ANNE ARUNDEL COUNTY PUBLIC LIBRARY
5 Harry S Truman Pkwy
Annapolis, MD 21401

ADDENDUM NO. 4

RFP 25-01

DISCOVERIES: THE LIBRARY THE MALL EXPANSION

ADD ALTERNATE #1 - PARTIAL DEMOLITION OF EXISTING UNDER-SLAB SANITARY PIPE
 SCALE: 1/8" = 1'-0"
 0 2' 4' 8' 16'

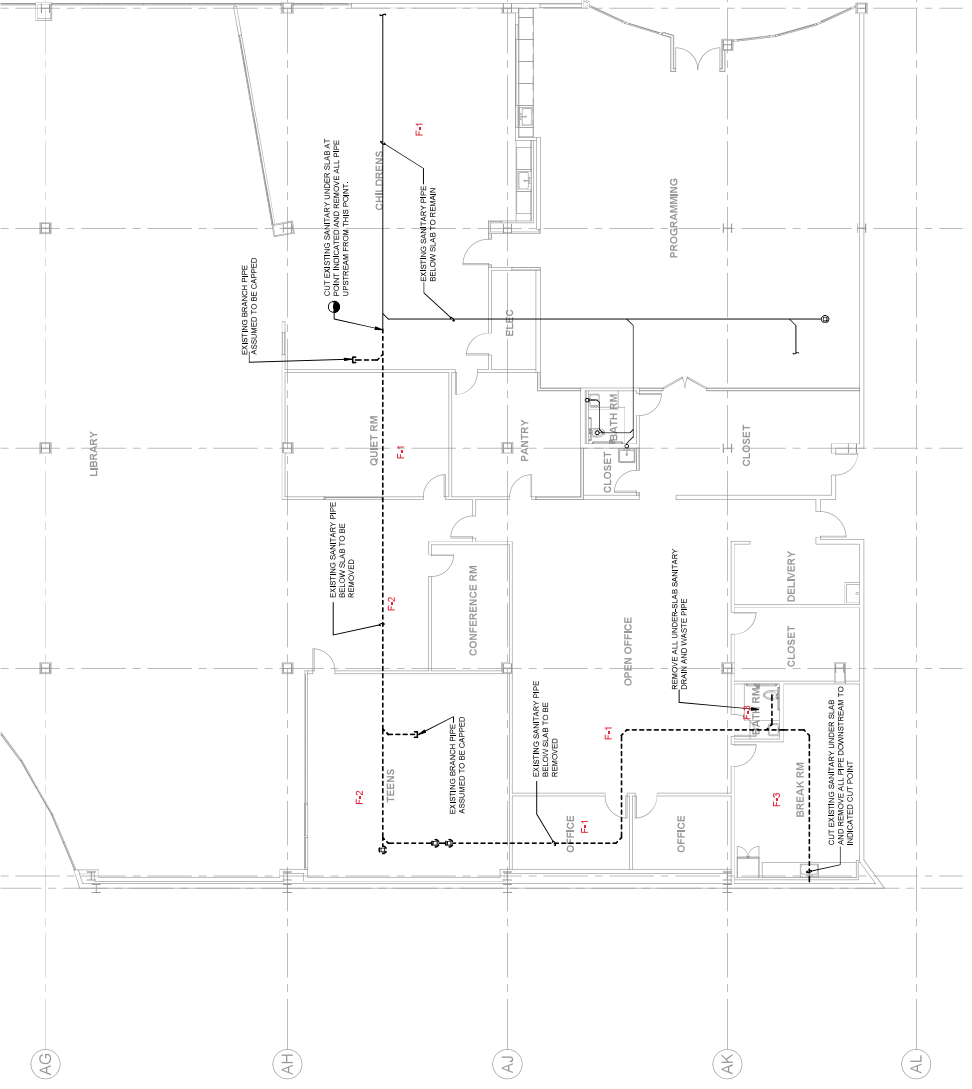
1. Alternate 1 shows the demolition of the flooring in the "NIC" areas. Please clarify the types of flooring/finishes in these areas.

ANSWER: Yes, existing flooring to be demolished at necessary locations to complete work in alternate 1. Flooring to be replaced in kind. See attached markup.
